Association of Universities for Research in Astronomy, Inc. ("AURA")

RFP-N84914C

"WIYN Facility Upgrade for the NEID Spectrometer"

AMENDMENT NO. 1

CRANE HANGER SUPPORT DETAIL

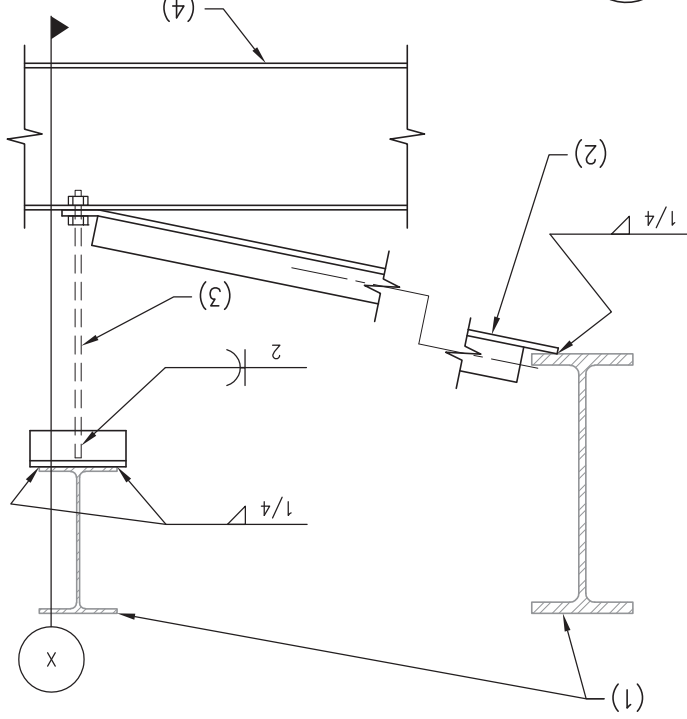
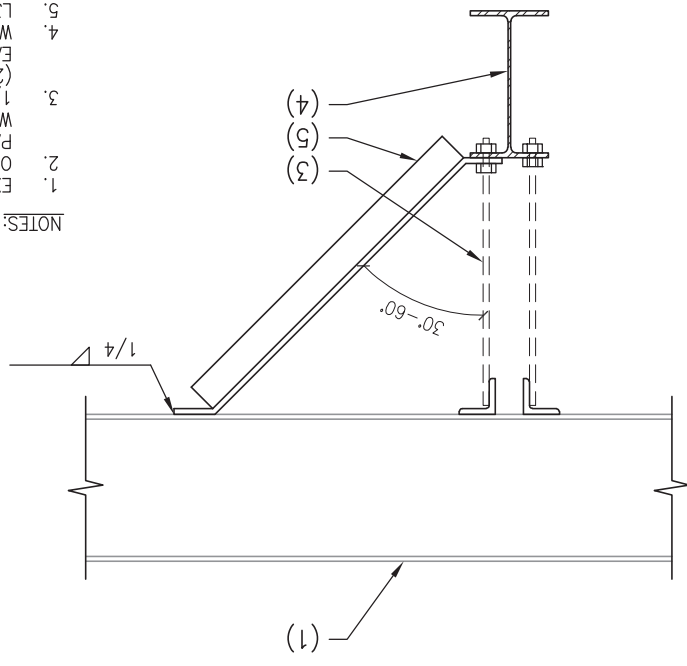
19. Hoist: Reference Sheet A-2.3 – RCP Keynote 9: provide manf, model # and/or complete criteria for the hoists and their support assembly. Indicate if installation is design/build. Provide structural context on existing beams from which the hoist(s) will be supported so as to allow design/building if such is the choice.

Please see the attached SK-1 for structural attachment detail of the connections of our trolley support beam to the existing structure. Contractor to provide and install (2) low headroom trollies with (2) low profile hoist capable of 1/2 total lifting capacity each. Refer to sections for hoist length requirements. Basis of Design: CM Manguard Electric Chain Hoist with 1/2 ton capacity.*

NOTE:
MAXIMUM POINT LOAD ON
RAIL/BEAM IS 5,000 LBS

- NOTES:
1. EXISTING STEEL BEAM.
 2. ONE L3x3x1/4 BRACE PARALLEL CRANE BEAM WHERE WILL BEST FIT.
 3. 1/2" DIA. THREADED ROD (2) ON BEAM GAGE AT EACH EXISTING BEAM.
 4. W6x12 STEEL CRANE RAIL.
 5. L3x3x1/4 BRACE AT EACH EXISTING BEAM.
